Health and Safety Objections – During Construction

All Chapter information references the EIS which can be found at: <https://www.planningportal.nsw.gov.au/major-projects/project/10451>. Go to EIS (73).

Figure 12-4 Construction dust screening assessment – receivers near the project footprint

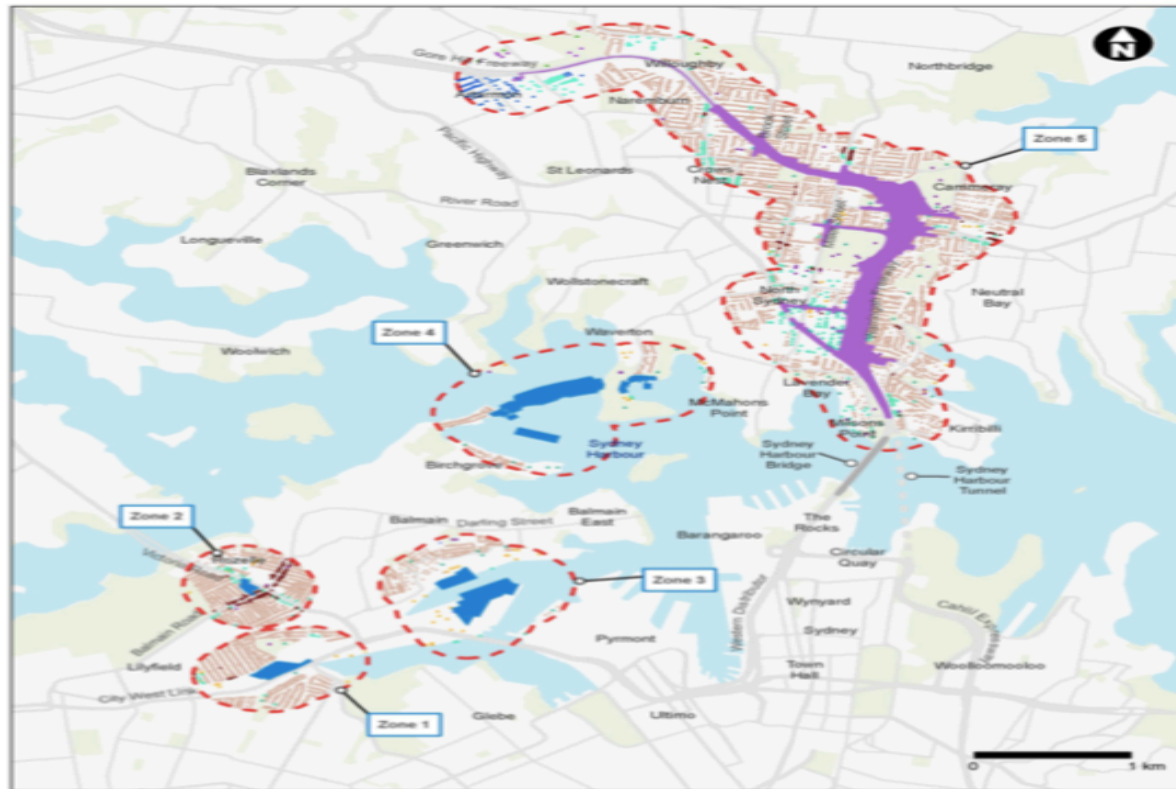
Objection: The dust impacts are assessed as high risk across the Warringah Freeway project a location which covers the area of many school and pre-school communities. The Warringah Freeway was built through historic areas where schools already existed and since this time the government has chosen to build more schools in this location. The health impacts to children of breathing in air high in particulate matter (that may be contaminated) is well documented in literature.

Mitigation: The Chief Health Office should be asked to reassess dust related health outcomes with reference to the risk assessment completed showing dust risks are high on the North Shore, soil contamination in the area has been identified, potentially contaminated spoil at Cammeray Golf Club site and the significant underestimation of educational receivers in the area.

Western Harbour Tunnel and Warringah Freeway Upgrade Construction Sites and Vehicle Movements

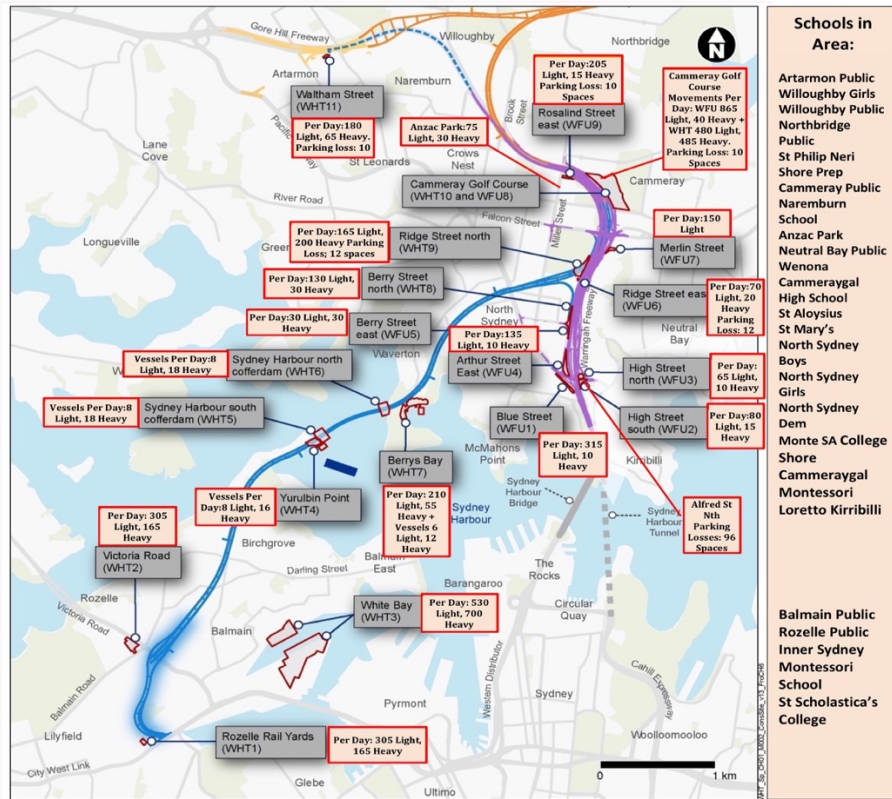
Objections: This is far too many vehicle movements in a school zone

Mitigation: Reconsider the project route and/ method of addressing congestion such as public transport alternatives. If this project goes ahead far stricter than usual conditions should be applied given the high proportion of children in the area.

How Noise has been Predicted

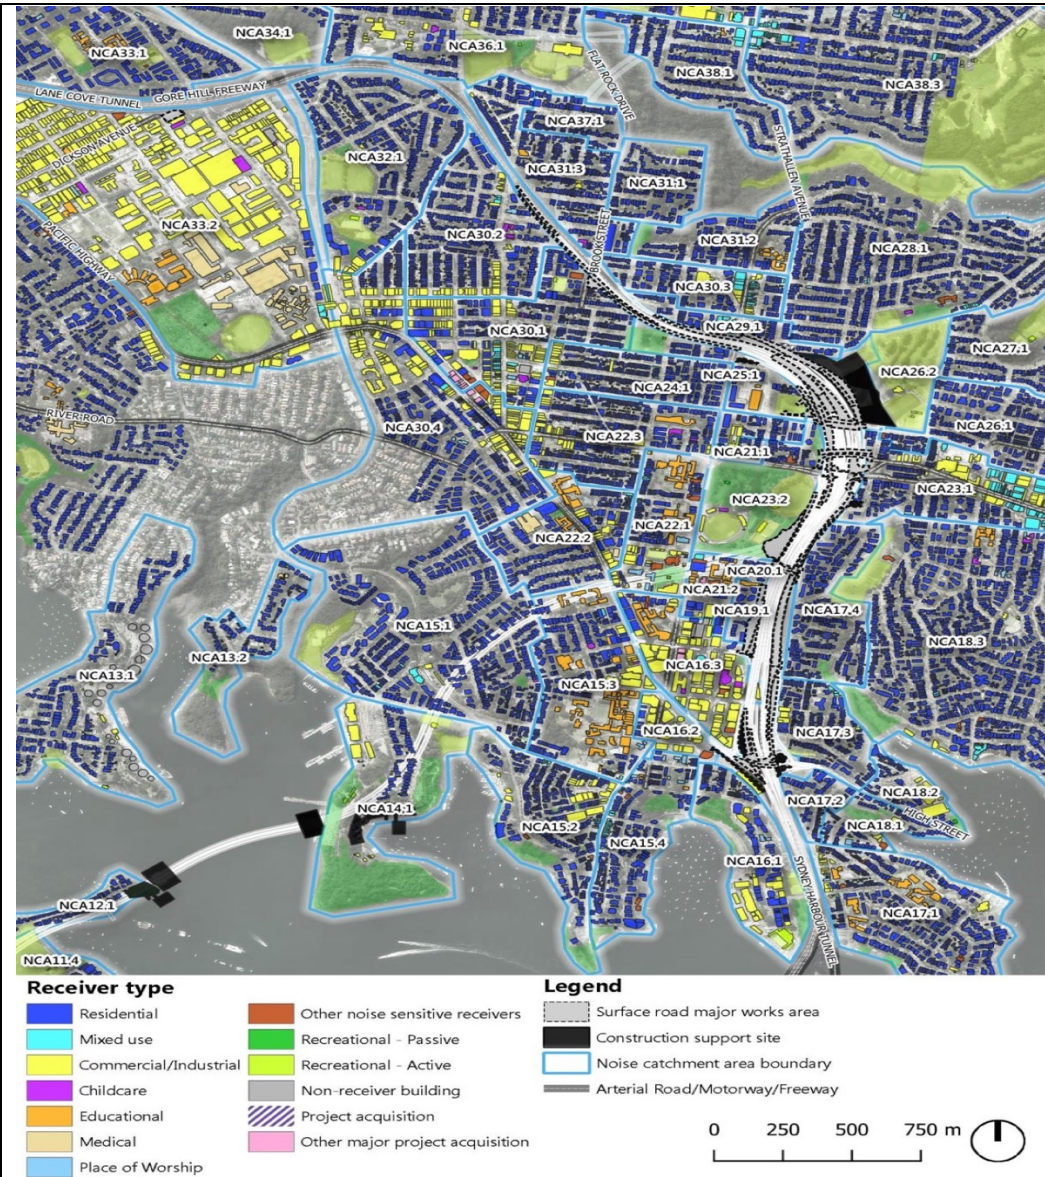
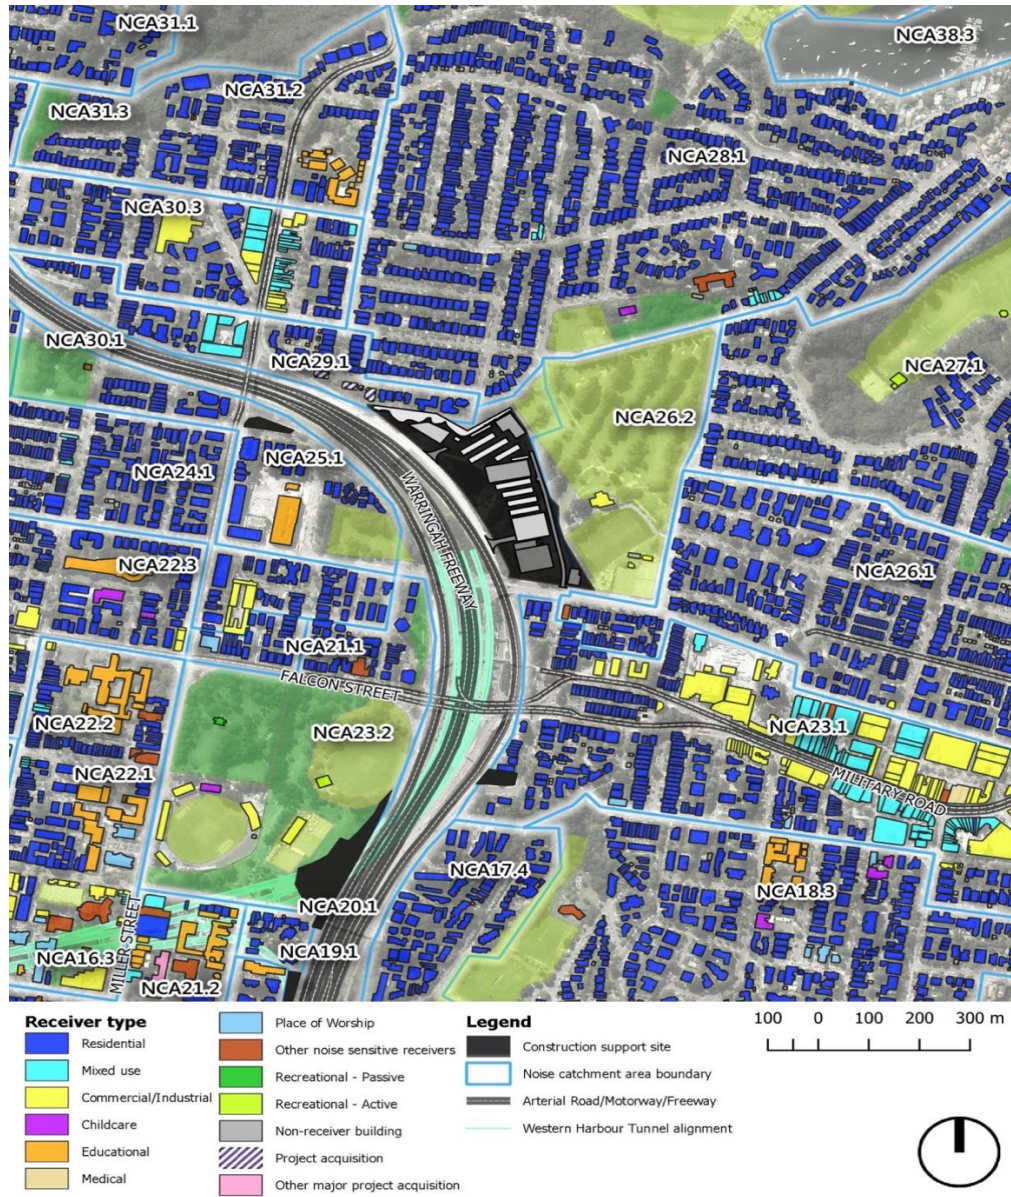
Objection: The information in the EIS relating to Noise is unnecessarily complex and does not enable a fair assessment of noise risks for individual receivers. Noise impacts are split up by work site and construction method and the documents state that more work needs to be done to determine noise impacts. Given the open nature of the Freeway, the Residential and Educational nature (26 schools along the alignment) it is critical that cumulative risks are known.

Action: Cumulative Noise Exceedances for all noise events should be displayed for each school and major sports field (i.e.) Cammeray Oval, St Leonard Park, Bicentennial Reserve in the area. The EIS should be reissued for consultation with this information contained for further consultation with community.

Miller St to Willoughby Rd Works – Out of Hours

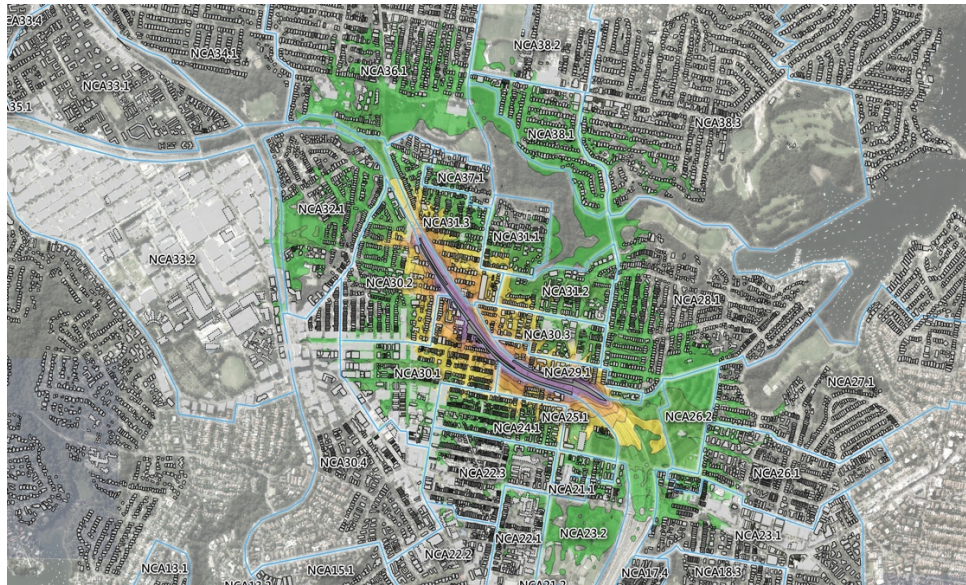
Objection: The surface works between Miller St and Willoughby Rd will generate substantial amounts of noise Out of Hours in a residential zone. Parks impacted will be Bicentennial Reserve, Flat Rock Gully, Tunks Park and Shore Oval. Given these parks are all used heavily for children’s sport noise impacts are a concern from a health and safety perspective (i.e. ability to coach/ manage kids safely. There is a high proportion of children and elderly residents living in the area who will be more impacted by out of hours noise. The health risks associated with long term noise exposure is well documented in the scientific literature. It is not clear how noise will be further impacted by coinciding works such as the planned Gore Hill extension and Beaches Link, Channel 9 site redevelopment and the planned Willoughby Leisure Centre redevelopment. Given the high noise levels in this area it is likely that any coinciding works would further exacerbate noise issues and place the area into noise well above limits.

Mitigation: Reconsider the route of the project due to the excessive cumulative risks. Should the project be allowed to go ahead at the existing alignment all the recommended risk mitigations listed in Appendix G: Page 780-782 should be applied with the highest rigour given the number of sensitive receivers. In addition, it should be a condition of approval that no further work on Gore Hill Extension or Beaches Link be undertaken until this work is complete. Additional noise barriers along the project footprint at this location and attenuation for residents and sensitive receivers should be a Condition of Approval. Noisy works should not be allowed to be scheduled during Friday afternoon and Saturday morning sport times as a condition of approval. A Schedule of coinciding works should be developed with Willoughby Council and compliance should be a Condition of Approval to avoid excessive noise from coinciding works. A construction transport plan across Willoughby should also be developed in conjunction with Willoughby Council to establish allowable truck movements, to identify local streets and transit corridors (esp. for children) and minimise noise from construction vehicles after hours. Trucks should not be allowed to use local streets where a high proportion of families and young children live such as Brook St, Small St and around school zones (i.e. 40 km/hr zones) and streets containing early childhood centres as a Condition of Approval.

Highest noise level envelope - Typical
WFU2H - Zone 2 (Falcon Street to Miller Street) Out of hours works

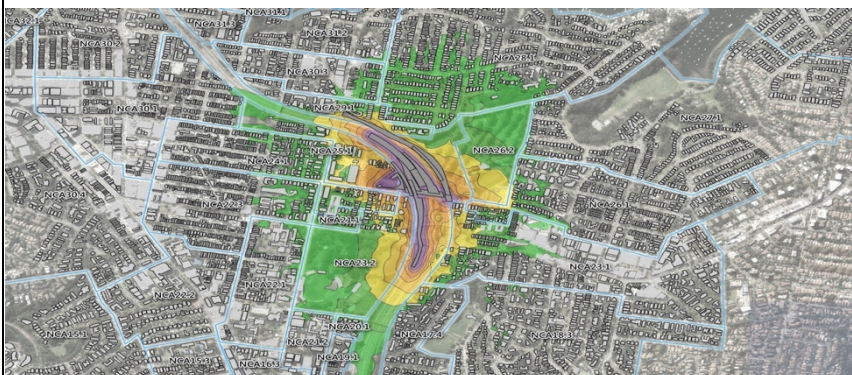
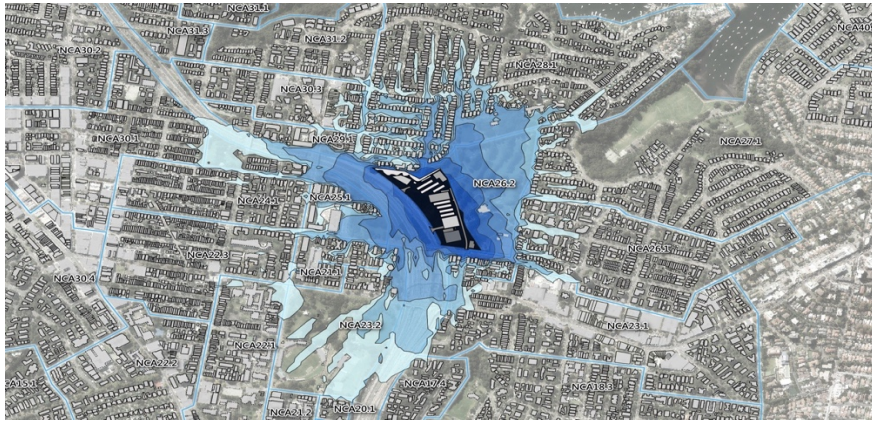
Objection: Significant Sensitive Receivers are located at the following locations within this Map Area and will be impacted by increased noise levels from coinciding works.

Rock Hammering – Major impacts to Wenona and surrounds

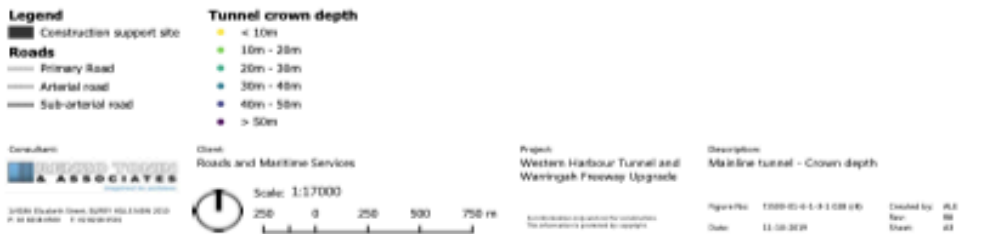
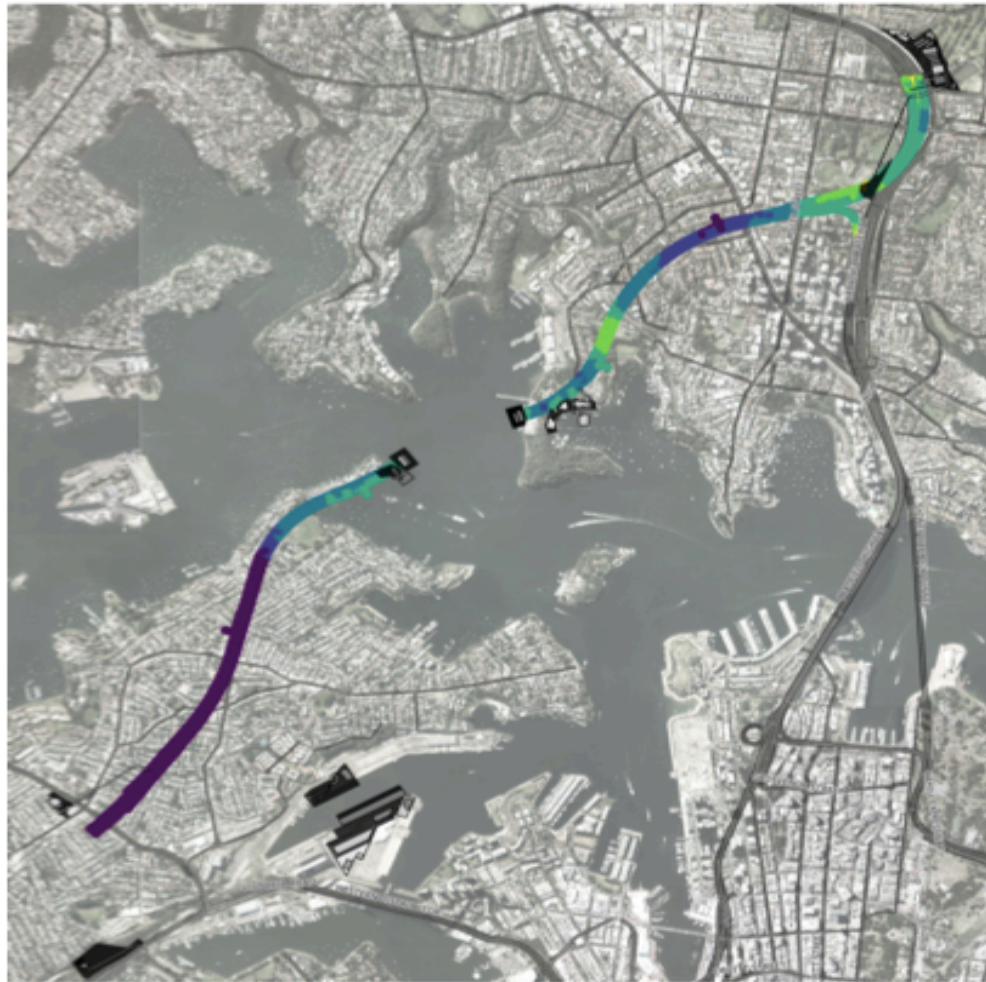
Objection: The Area will also be heavily impacted during Rock Hammering with several buildings, including Wenona, subject to ground born levels above 50dB. Given classrooms are supposed to reach an internal noise limit of 40dB and breadth of coinciding works it is unlikely that this will be able to be achieved at Wenona.

Action/ Mitigation: The route should be re-considered to avoid the highest density of schools in Australia. The cumulative impacts of re-constructing the Warringah Freeway and tunnelling activities and the risk to children are severe. The Warringah Freeway should as a minimum be bypassed and but preferably the Dee Why to Chatswood Rail corridor should be considered. An alternative Public Transport Feasibility study should be provide and compared across all risks including noise.

Coinciding Works at Construction Support Sites - Harbour Sydney Harbour Crossing –Standard hours - Build cofferdam - Impact Pilling - Sydney Harbour north cofferdam (SHC_01)

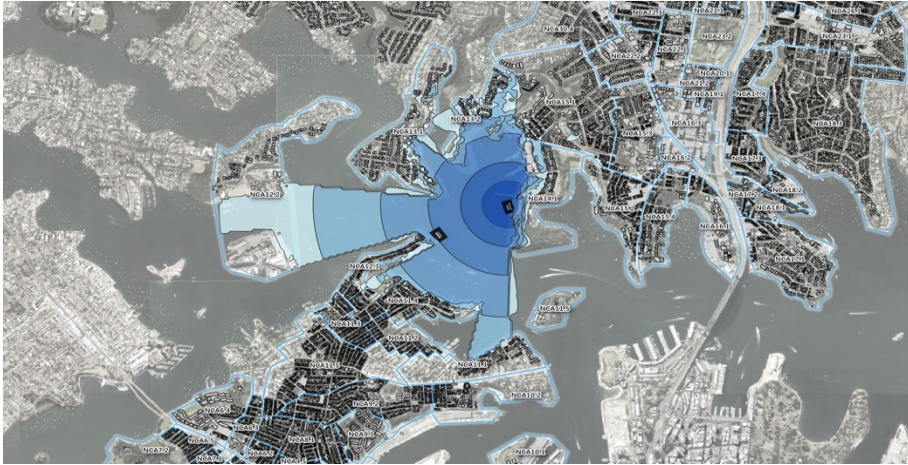
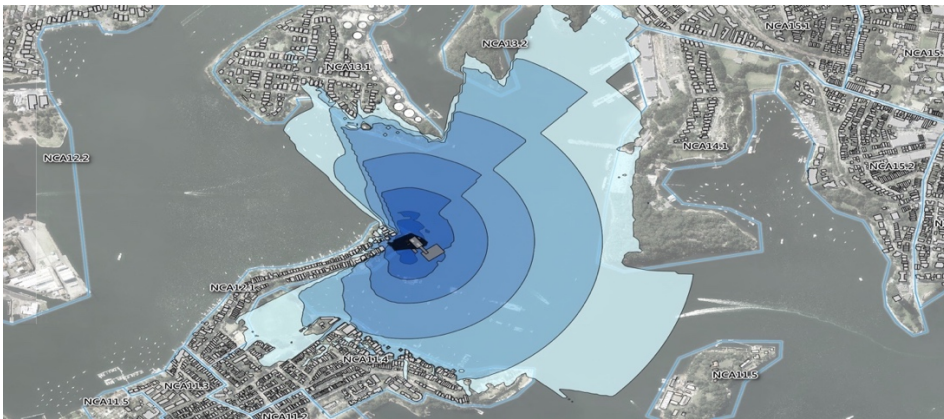
Objection: Significant Noise impacts will be experienced at Waverton and coinciding works will have a far-reaching impact as sound travels across the harbour from each support site. Please see Appendix G: for more detail. The choice of an immersed tube construction creates much of the noise due to the need to build coffer dams and dredge the harbour. Other options would require more foreshore area to build but would create far less noise and environmental impact during construction. The Metro tunnel is not an immersed tube tunnel
